BEFORE INDEPENDENT HEARING COMMISSIONERS APPOINTED BY THE  
TASMAN DISTRICT COUNCIL

Application for resource consent by  
**Māpua Community Boat Ramp Trust**

STATEMENT OF EVIDENCE OF GARY NOEL STEVENSON  
ENGINEERING

Dated: 1 November 2024

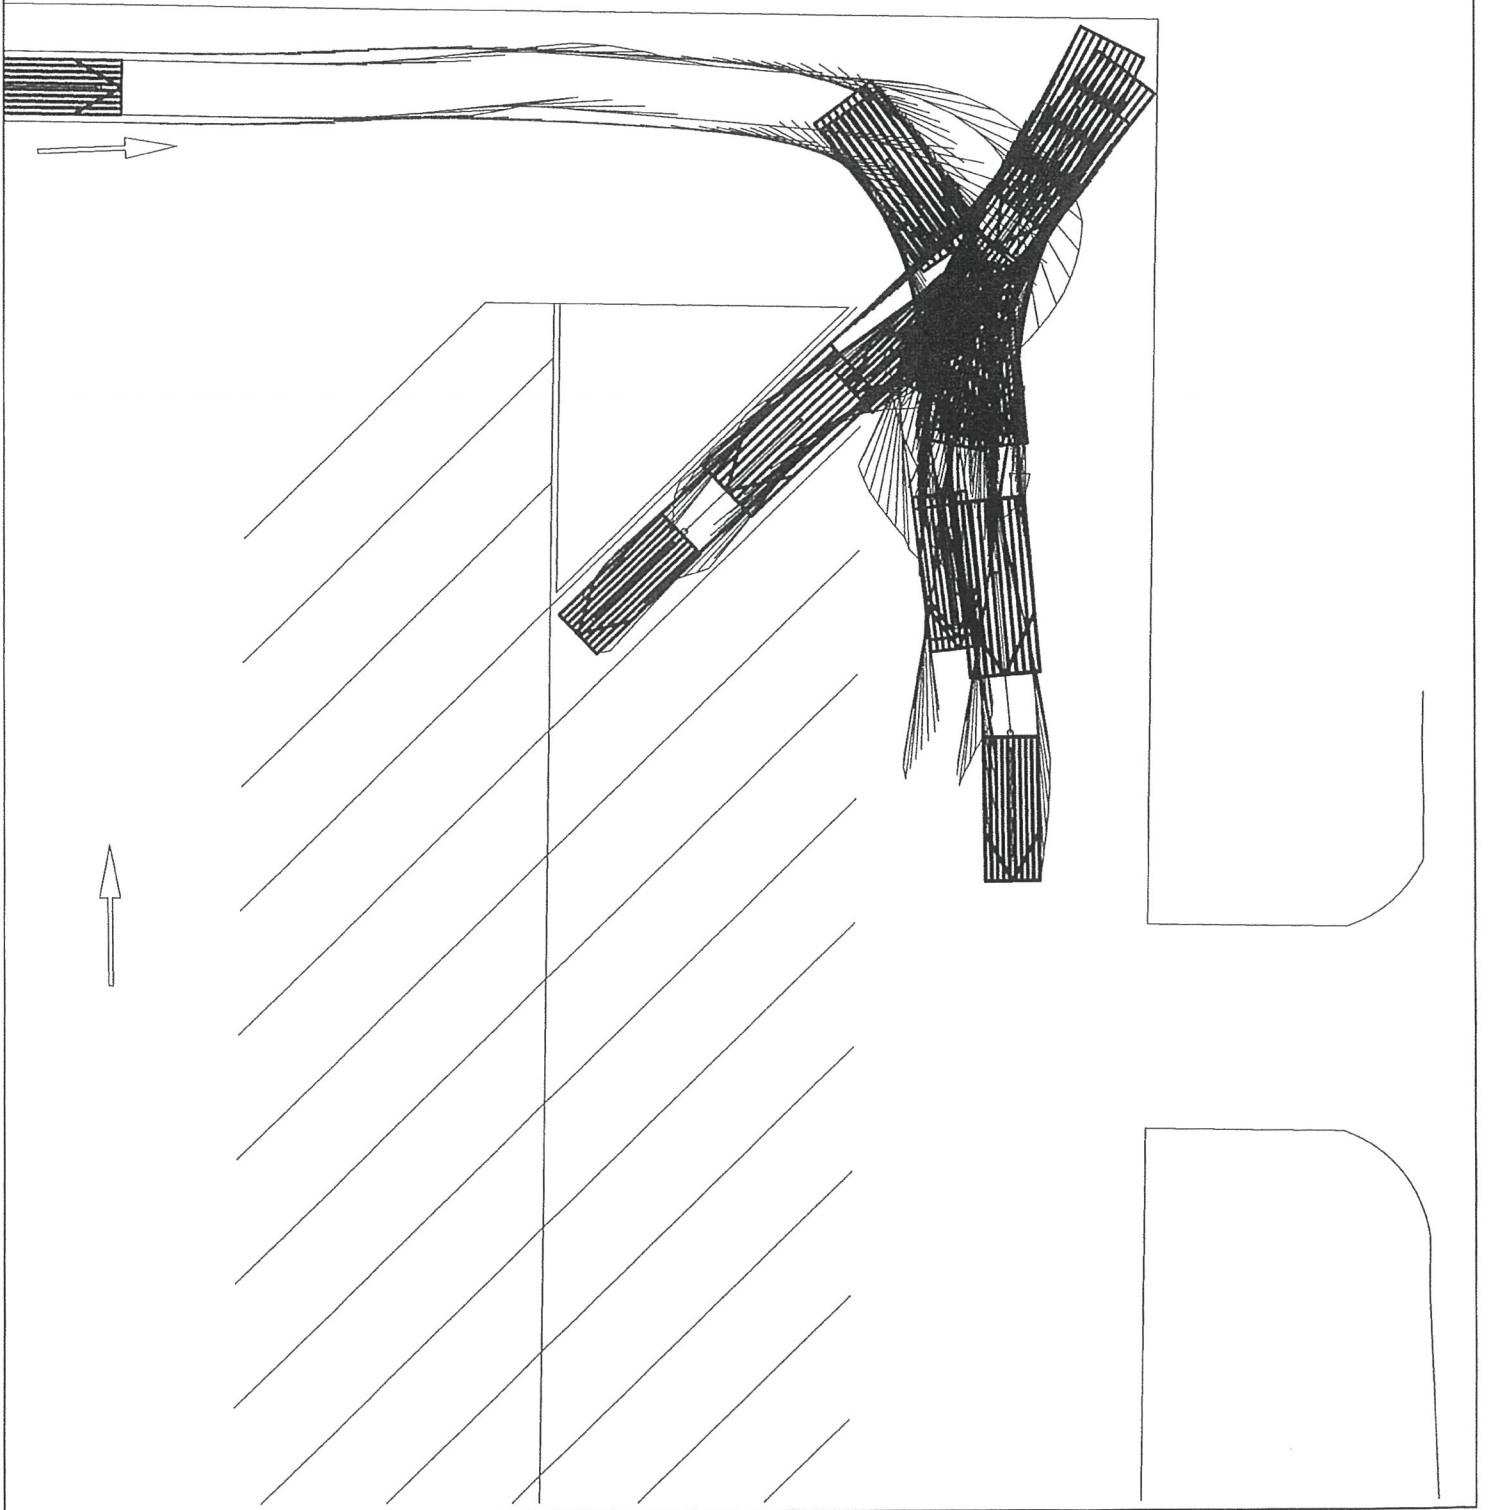
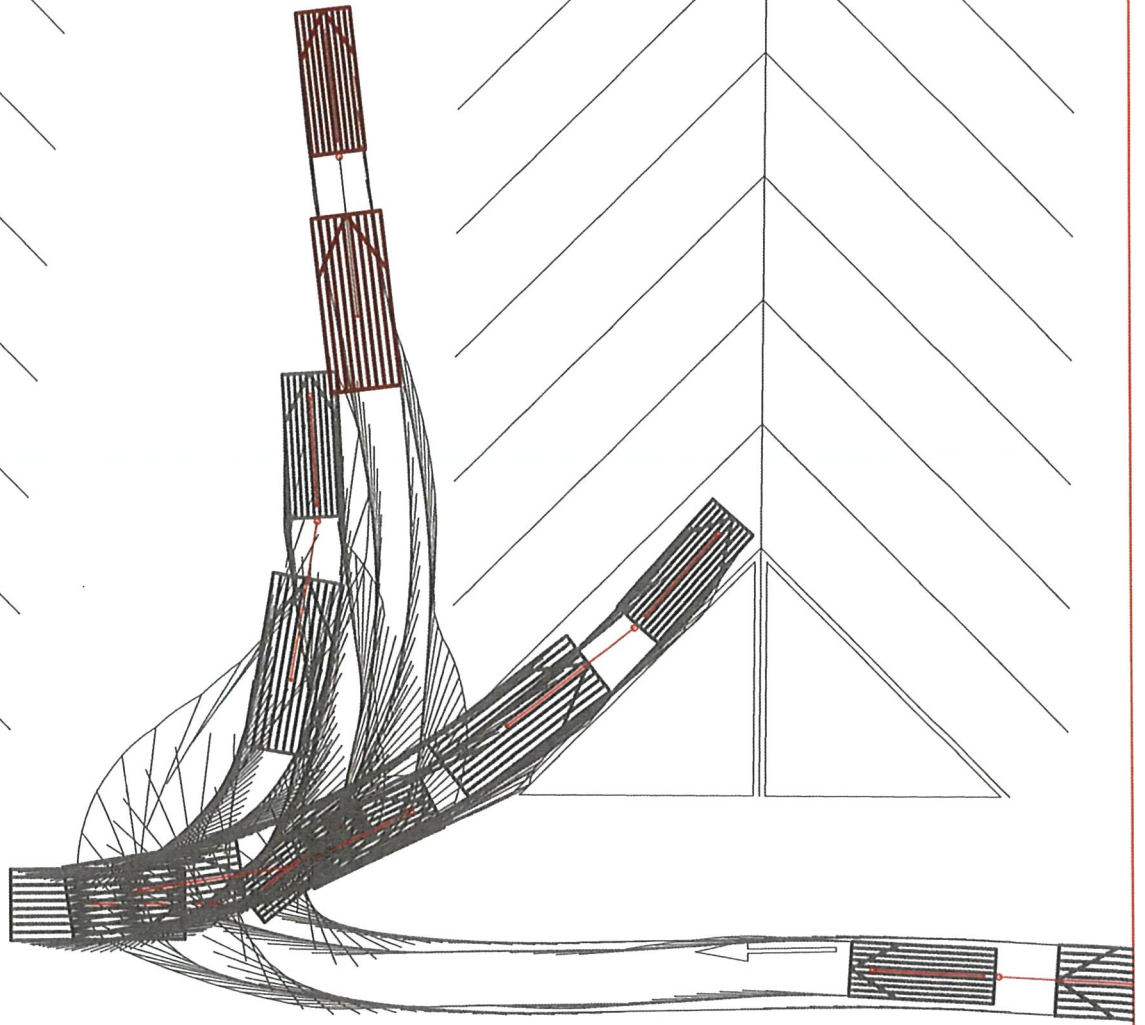
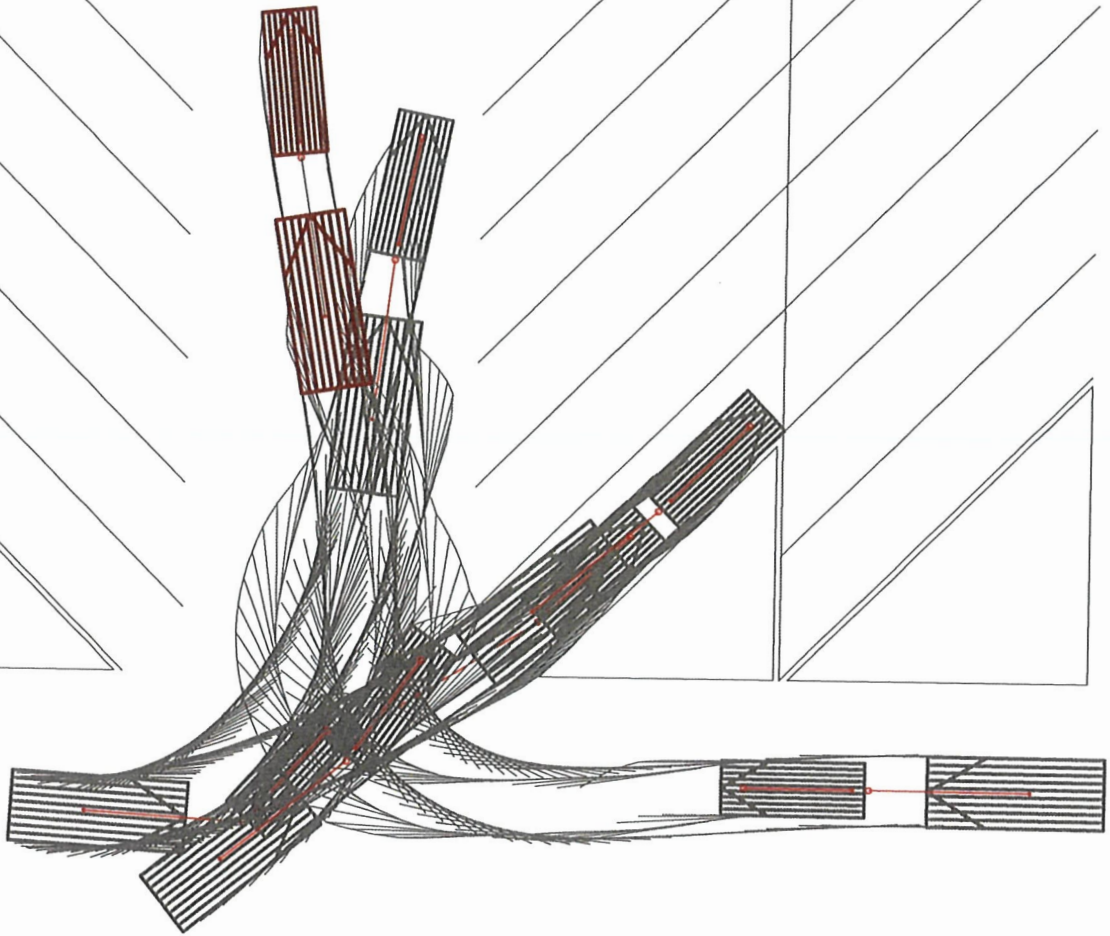
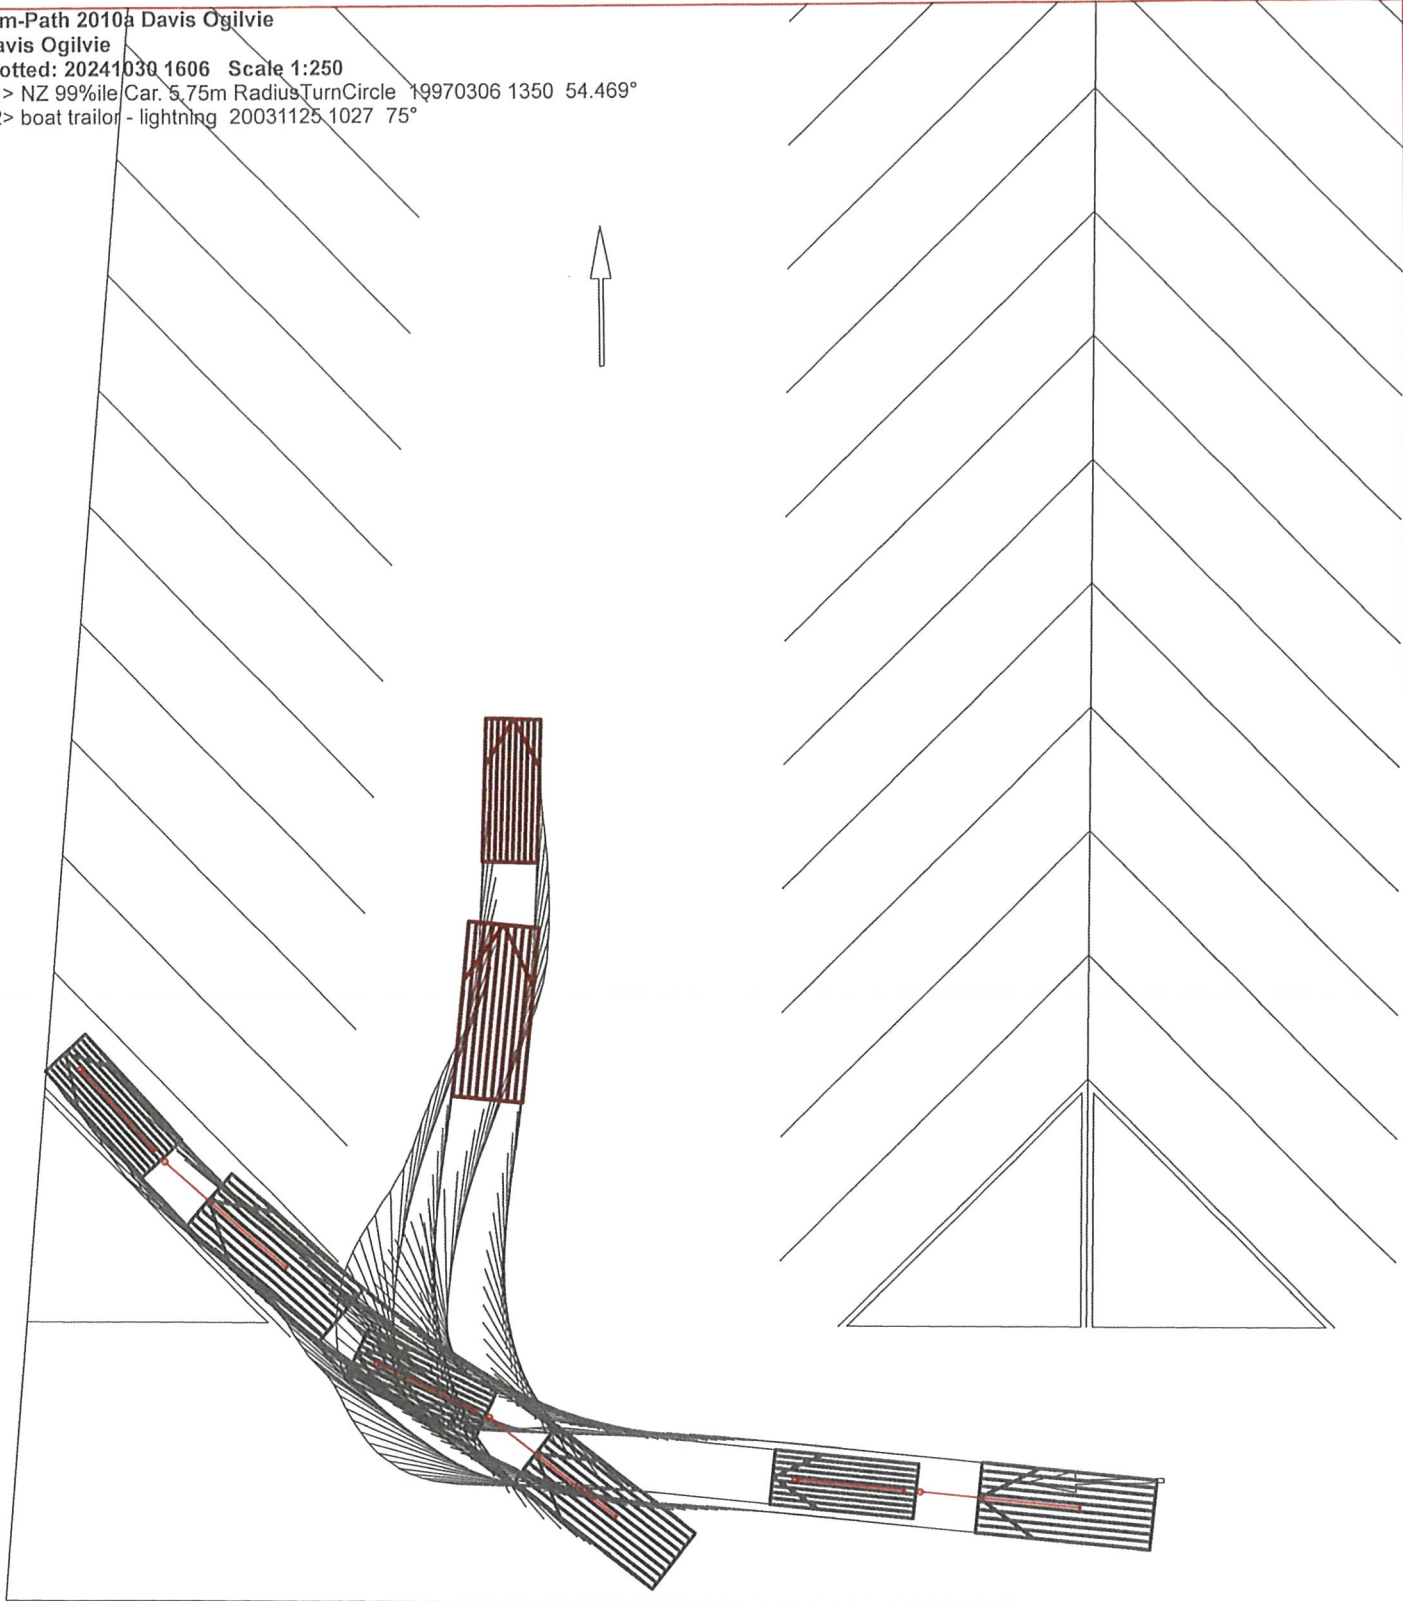
22. (S42, 14.11) Stantec raised concerns with swept paths of 10 parking spaces located in the western car park.

24. (s42, 14.23 & 14.24) Stantec have noted that tracking curves have not been provided for manoeuvring through the car park from the accessway barrier arm and on the ramp.

I comment: Annexed is a swept path analysis drawing that shows these parks can be utilised. I note that the parking is also provided for overflow parking and can be utilised for this purpose.

I comment: I annex tracking curves to show that this is achievable.
